Capitola City Council

Agenda Report

Subject: Capitola Mall and Objective Standards Zoning Code

Figure 1. Comparison of 75 feet and 125 feet Perimeter Zone

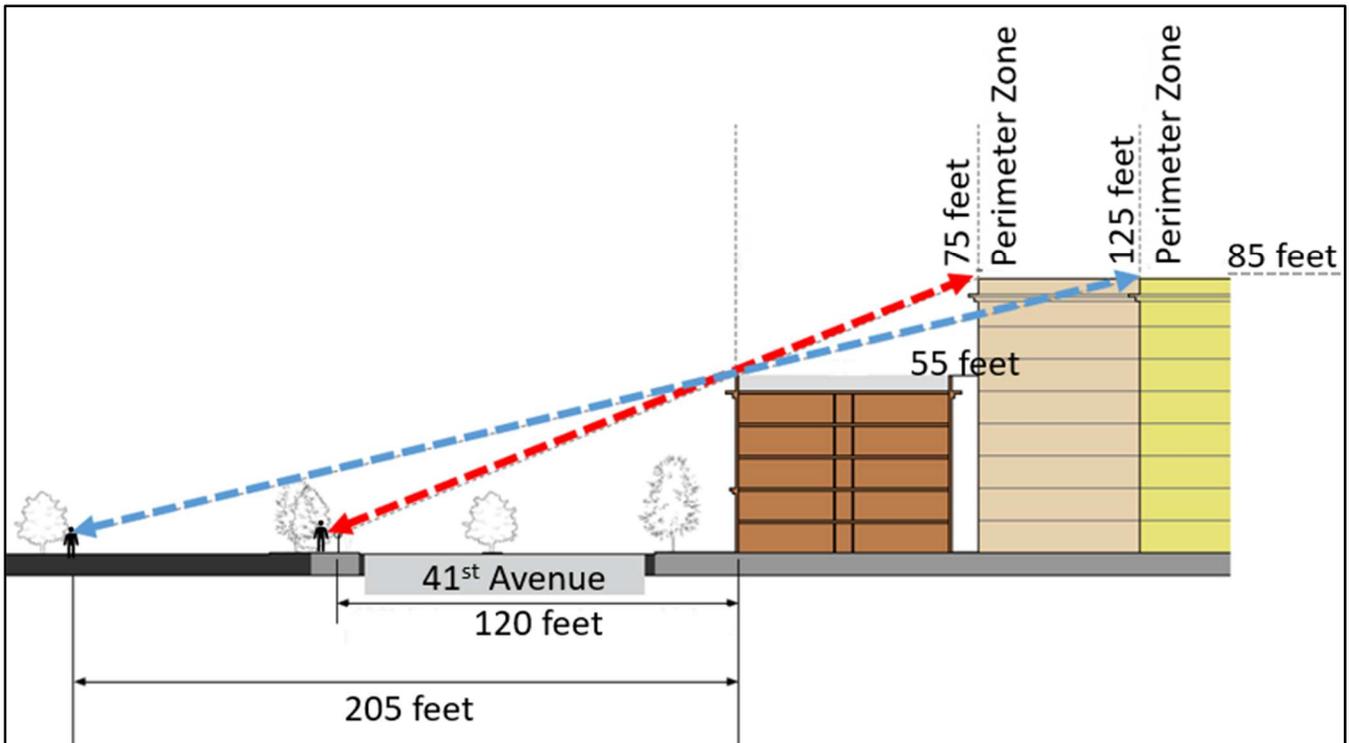
MGP Request: Reduce perimeter zone to 75 feet.

Overview: The draft ordinance includes lower maximum height limits in the perimeter zones to screen the massing of the taller buildings within the core area of the Capitola Mall properties. For instance, the maximum height for Tier 1 projects is 55 feet in the perimeter zone (within 125 feet of 41st Avenue, Capitola Road, and Clares Street) and 75 feet in the core zone (areas other than the perimeter zone).

Figure 1 shows a 55 feet tall structure in the perimeter zone and an 85 feet tall structure located 75 feet and 125 feet from the property line. With a 75 feet perimeter zone, the 55 feet structure screens the 85 feet structure as viewed from sidewalk on the opposite side of 41st Avenue. With a 125 feet perimeter zone, the core area 85 feet buildings are screened up to 205 feet away.

City Council Input: Several Council Members supported reducing the perimeter zone to 75 feet fronting 41st Avenue and Capitola Road as part of Council Member Westman's Tier 2 proposal. Council Member Westman also included a height limit of 75 feet within the perimeter zone, which she later informed staff should have been 65 feet.

Staff Recommendation: Staff recommends reducing the perimeter zone to 75 feet for Tier 2 and Tier 3 fronting 41st Avenue and Capitola Road and maintaining the perimeter zone of 125 feet along Clares Street.

“Perimeter zone” means all areas on the Capitola Mall property that are within 75-125 feet of a property line abutting 41st Avenue or Capitola Road and within 125 feet of a property line abutting Clares Street.

Figure 2 Commercial 18 feet floor-to-floor measurement

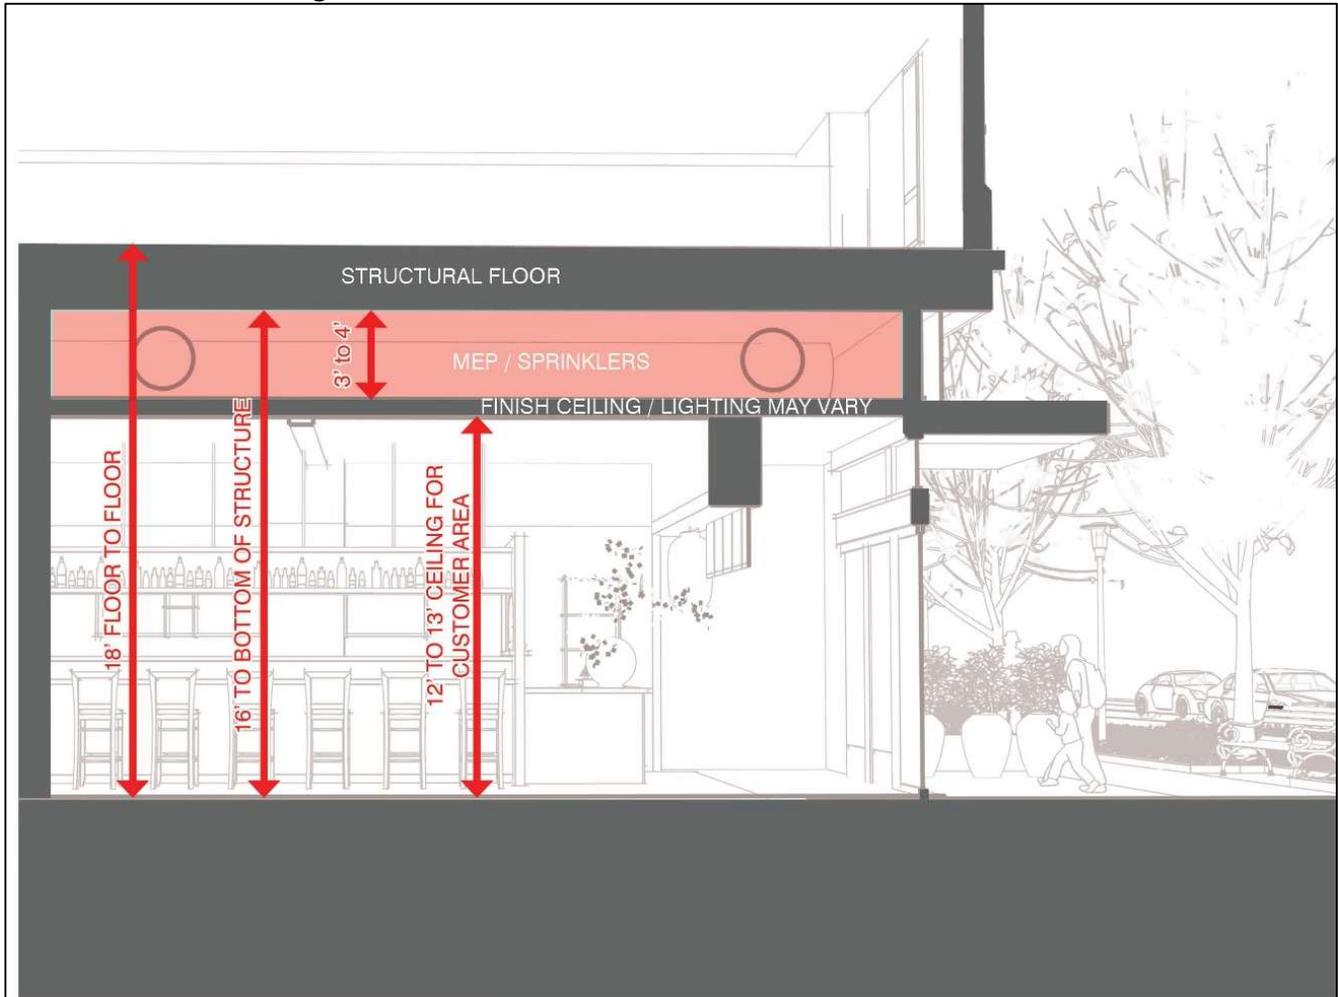
MGP Request: Reduce minimum ground-floor height for non-restaurant commercial and hotel uses to 14 feet.

Overview: The original draft code required a minimum commercial ground floor height. Specifically, the ground level would have minimum floor-to-floor height of 18 feet. For single-story buildings, minimum ground floor height is measured to the top of structure. Floor-to-floor height is a planning term that refers to the vertical distance from the top surface of one finished floor to the top surface of the finished floor above it. A typical floor-to-floor dimension incorporates the occupied space above the finished floor, a finished ceiling, the area above the finished ceiling utilized for mechanical, electrical, and plumbing, and the structural floor above.

Figure 2 below shows dimensions for floor-to-floor measurements with the 18 foot requirement.

Staff Recommendation: Staff recommends modifying the ceiling heights to be measured from the finished floor to the bottom of the structure. For any tier-required new commercial space, require a minimum 16 feet clear from the ground floor to bottom of structure, as shown in Diagram 2. Also, update the code so new commercial space provided which exceeds the minimum tier-required amount is exempt from this minimum height requirement. For example, if the City Council required 35,000 square feet of commercial to qualify for Tier 2, any commercial space beyond the required 35,000 square feet would not be required to meet the minimum height standard. The draft ordinance includes the updated language recommended by staff.

(1) Ground Floor Height. For all required new commercial space required for a Tier 2 or Tier 3 project, the ground level shall have minimum floor to floor height of 18 feet 16 feet clear from the ground floor to the bottom of the structure above. See Figure 17.57-9. This minimum ground floor height standard does not apply to commercial space provided in excess of the required new commercial minimum. For single-story buildings, minimum ground floor height is measured to top of structure.
